SECTION 4.55 DA
MODIFICATION

URBNSURF SYDNEY
SYDNEY OLYMPIC PARK, NSW

SECTION 4.55 DA MODIFICATION

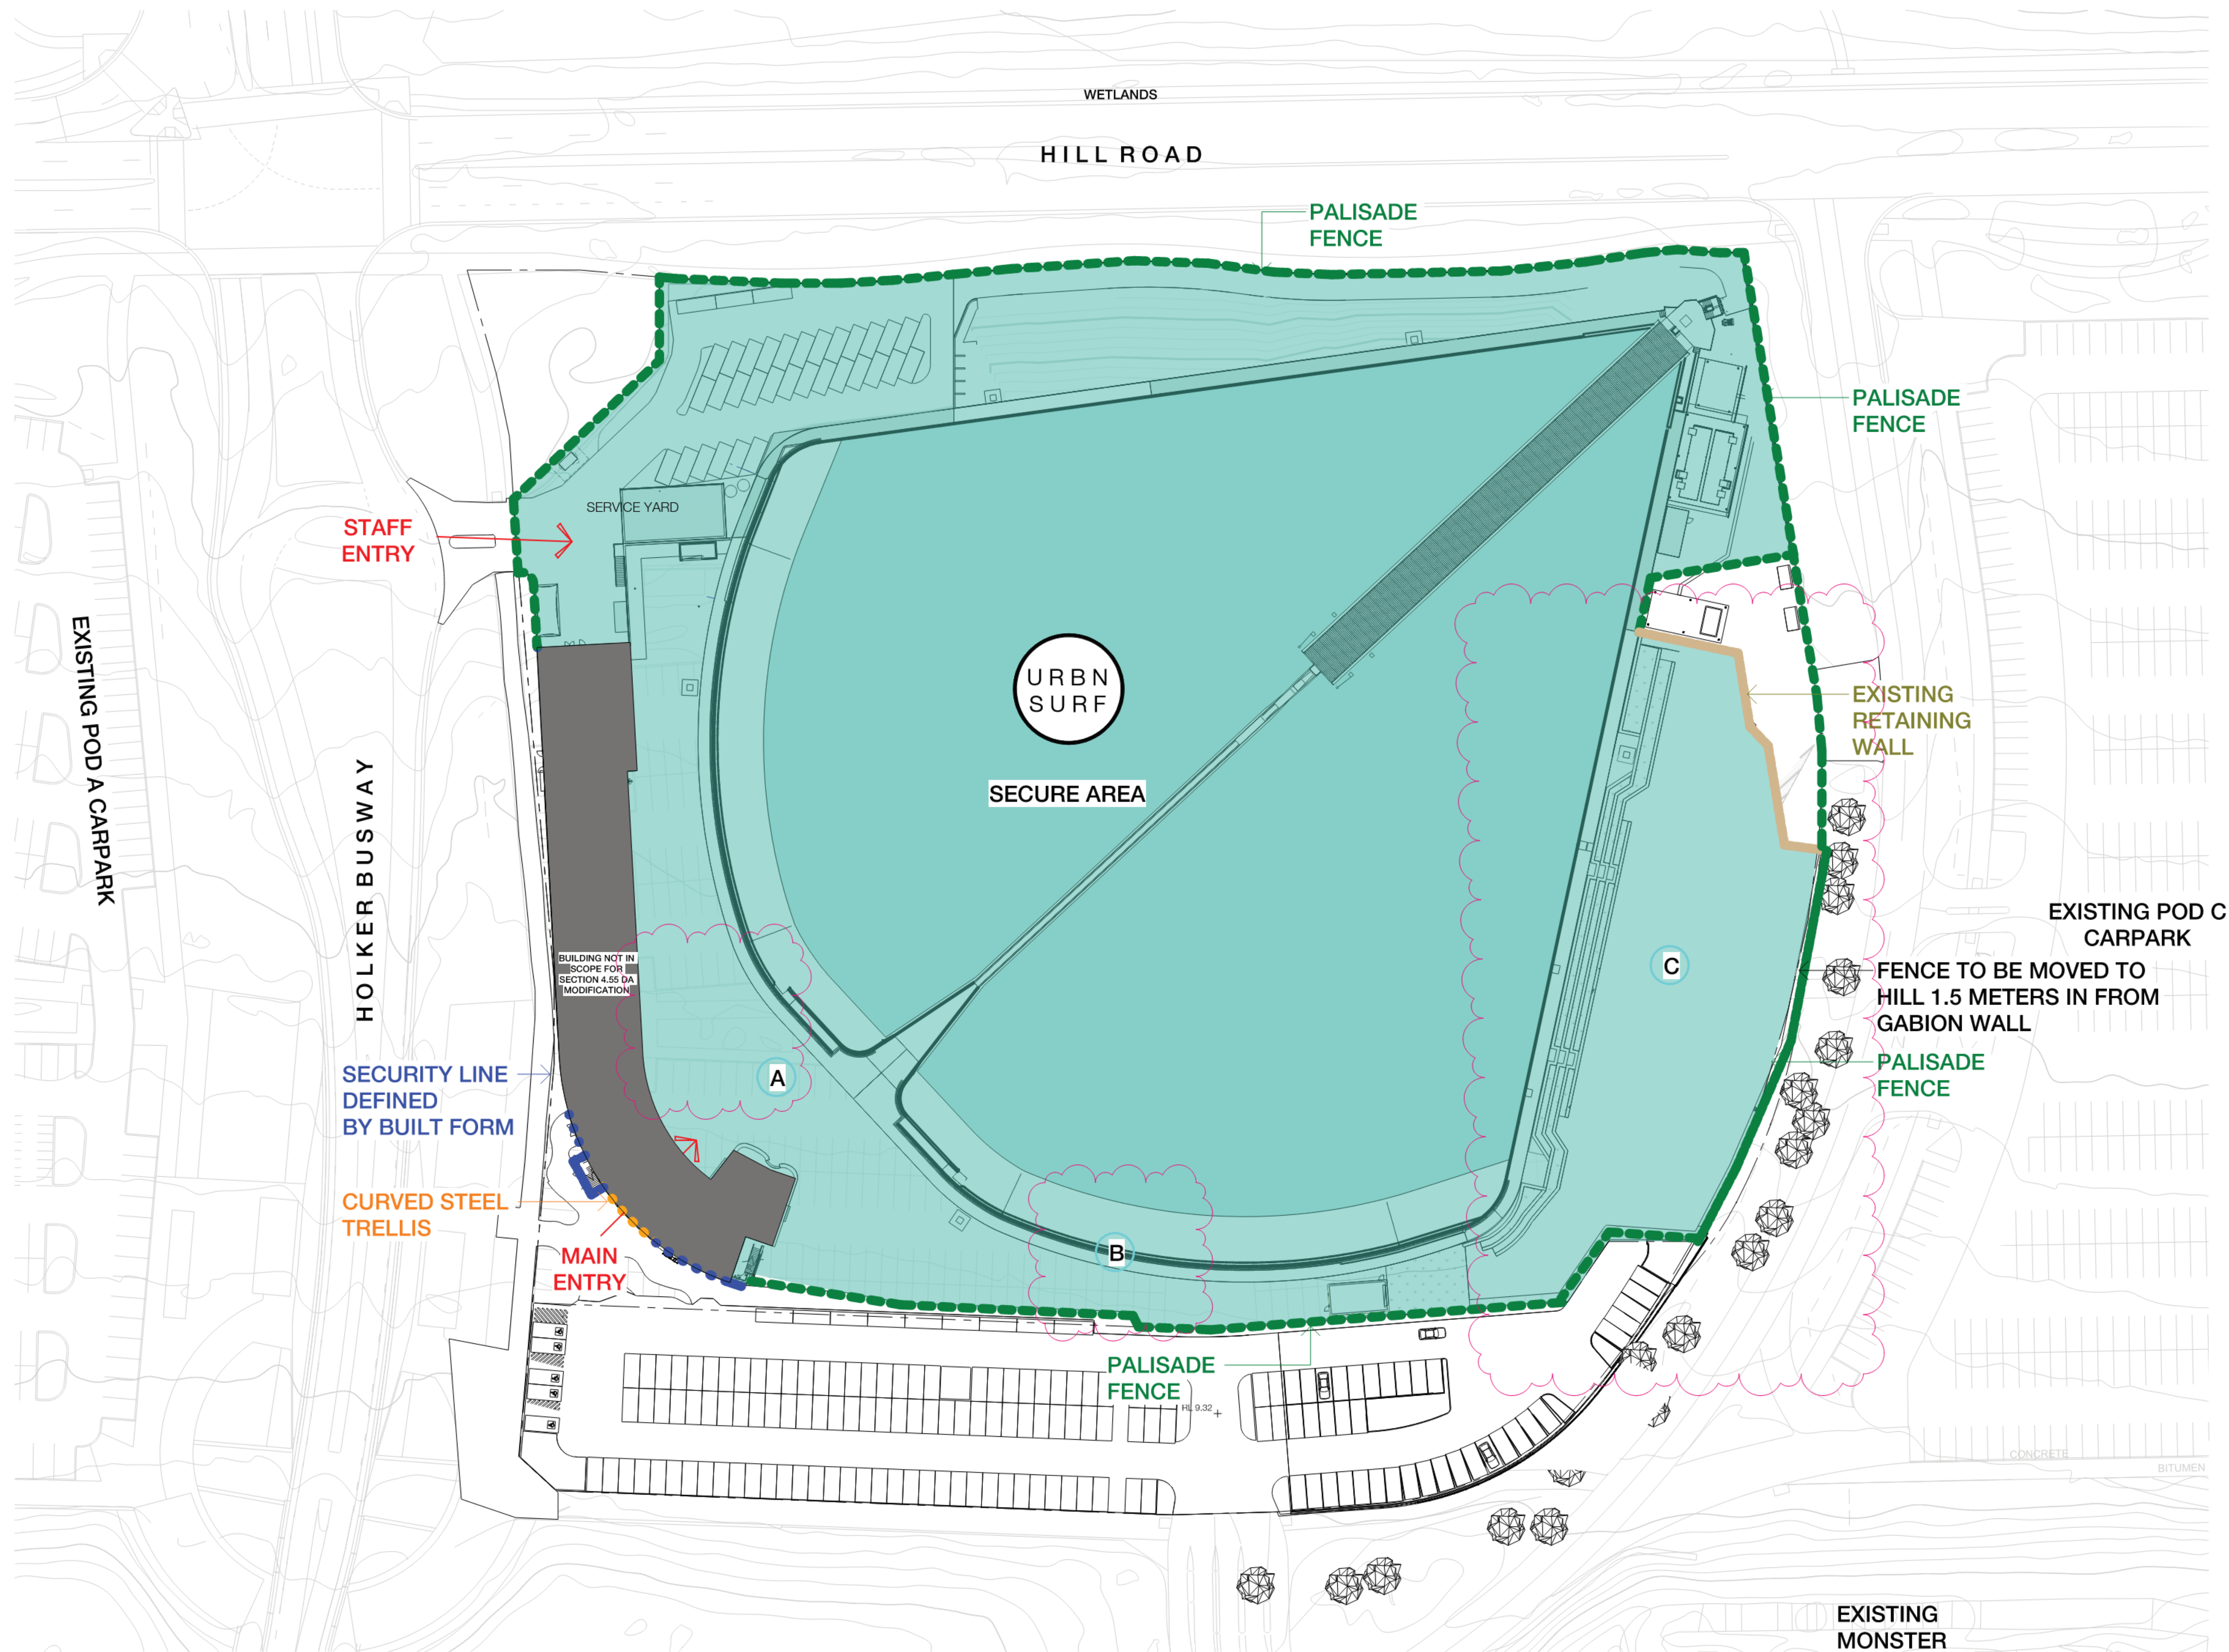
- A** Design Change 1: Playground area replaced with lawn space (Landscape)
- B** Design Change 2: Kids pool replaced with lawn space (Landscape)
- C** Design Change 3: Revised Eastern Hill landscape design
